Downtown Development Review Overlay (DDRO) District

Report of the Urban Design Administrator to the Committee

19-OVERLAY-0027

Angel's Envy, 101 S Jackson Street; 500 E Main Street; and 508

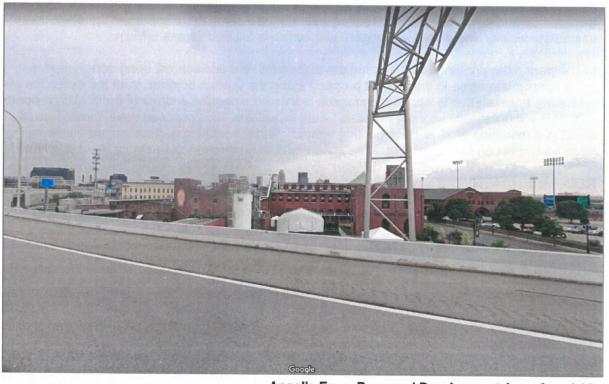
While sympathetic to the historic portion of the structure, the new addition is identifiable and has a design that clearly indicates that it is not historic or original to the site. The building will match the 2015-16 addition, which strongly relates to the historic building. Both the additions and the historic structure have a predominant height of 2-stories (circa 42'). The building additions and the historic structure are composed of red brick and include similar design features such as corner pilasters with limestone caps, limestone window sills, and a terracotta parapet cap.

The addition has arch top windows that mimic the historic building's windows that have the same design and radius shapes. However, to reflect that they are part of a newer addition, the addition's windows are differentiated from the historic structure's windows by being less detailed. The addition's windows have fewer muntin bars (five larger panes as opposed 20 smaller panes) and are a different material (aluminum).

A door is proposed on the E Main facade of the addition for exiting only. Visitors to the complex will continue to enter through the current main entry. The doorway also has an arched top and, albeit less in width and height, mimics the design of the doorway of the historic building on E Main.

Considering the information furnished, the Urban Design Administrator recommends **approval** of the application for an Overlay Permit with the following conditions:

- Prior to the issuance of a building permit for the new building, finalized design details and materials shall be submitted to staff for final review and approval. If the design or materials change, the applicant shall contact staff for review and approval prior to installation.
- 2. Public art is always encouraged to enhance the quality and design of projects in the district. Any public art proposals shall be submitted to staff for review and approval
